## ADDENDUM #6

RFQ#7597658

TITLE: RIDOT MATERIALS LABORATORY RENOVATIONS

# RFQ #7597658--RIDOT Materials Laboratory Renovations

**Basement Plan**

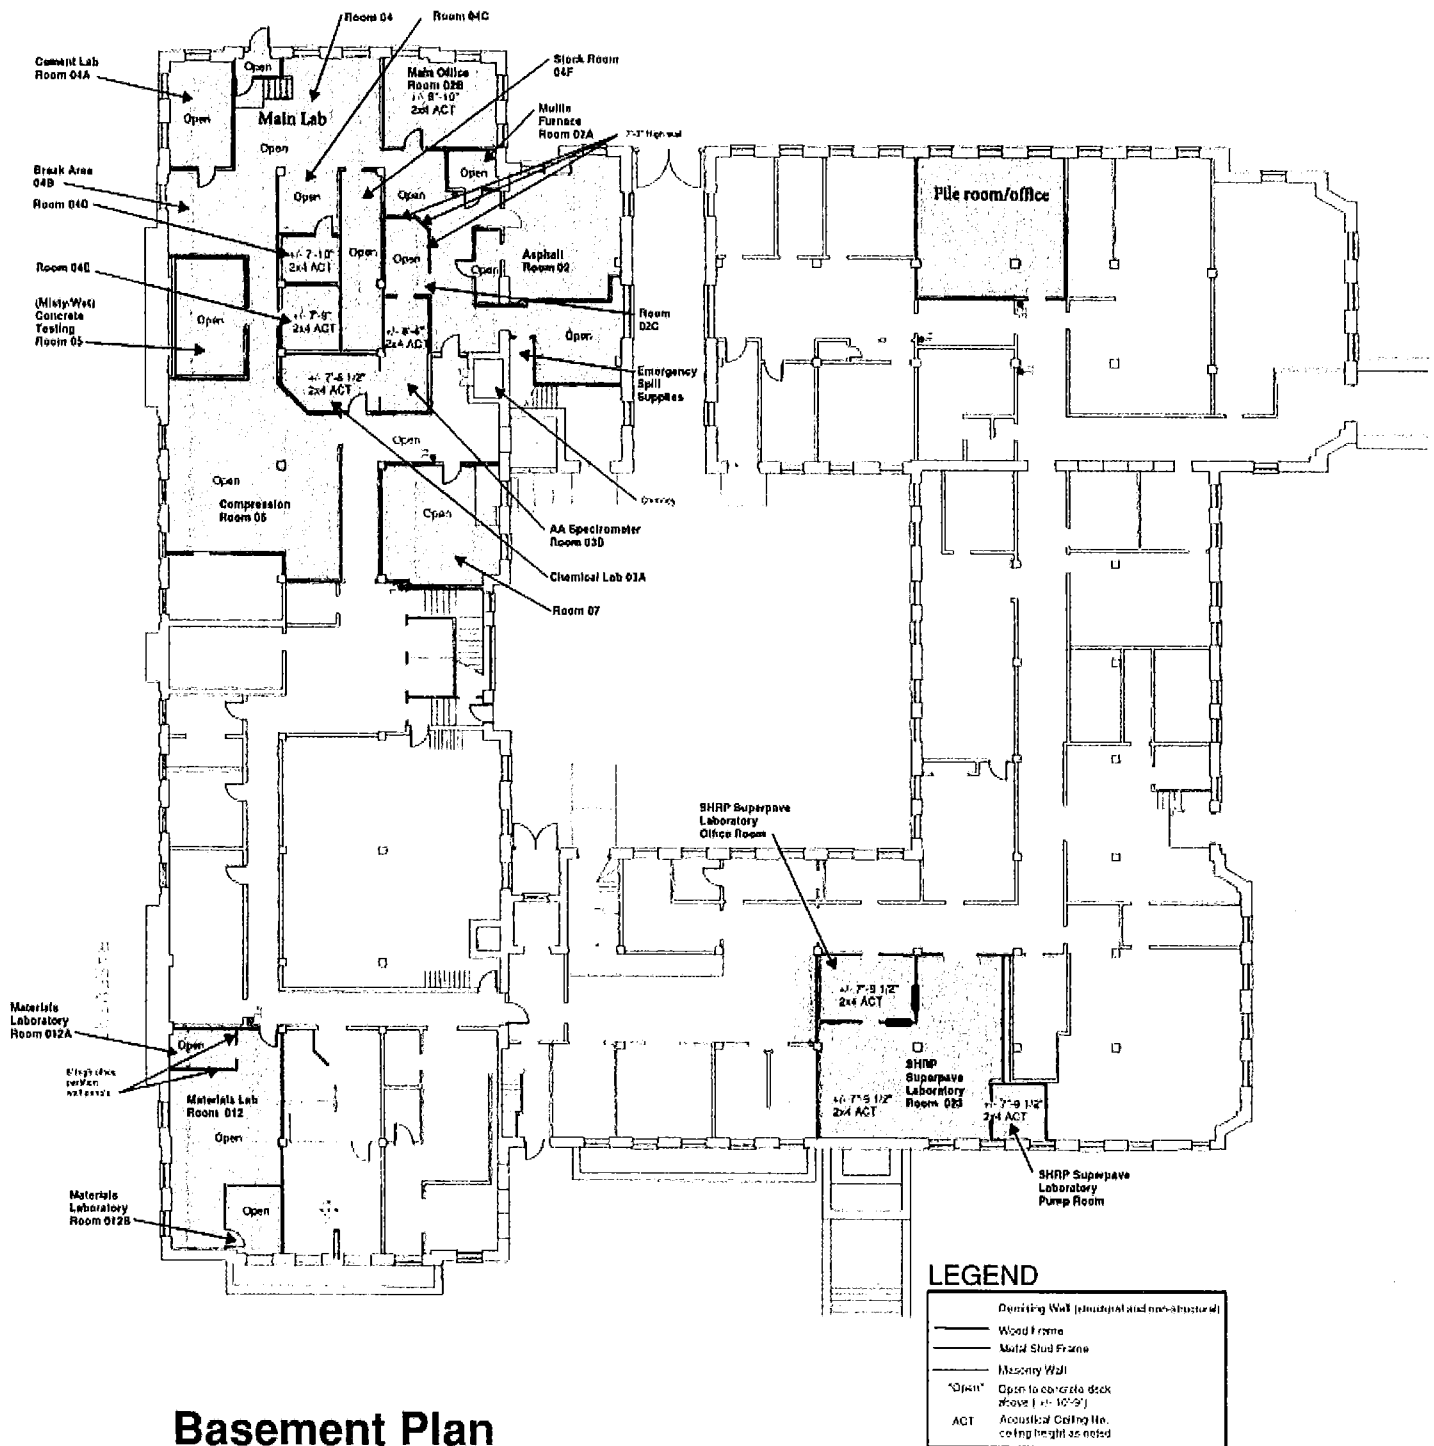
1. Drawing D-100- Keyed note #4. The demo drawing doesn't seem to indicate what kind of wall is being partially removed. Please provide this data and please advise if structural work will be required. If yes, please provide a detail. ***Chemical Testing 03 & Wet Room 05 is double thick brick wall and will require door galv steel lintel to be installed at the head with 4" embedment each side. Asphalt Lab 02, Muffler Furnace/Storage 02A, Soil Test 04E, Compressors Storage 06A & Freeze/Thaw 012B is Non-load bearing wood stud wall, gypsum board and homasote/fiberboard finish both sites***

2. Drawing D-100- Keyed note #6. What is the depth of the existing and new drain (P-100)? If this is unknown, please consider setting a depth for all contractors to carry, so the bidding is based on the same data. ***It is 20" below floor slab.***

3. Drawing D-100- Keyed note #20. What is the wall type? ***Non-load bearing wood stud wall, gypsum board both sides (one side finished with wood laminated paneling) below and above fixed glass window.***
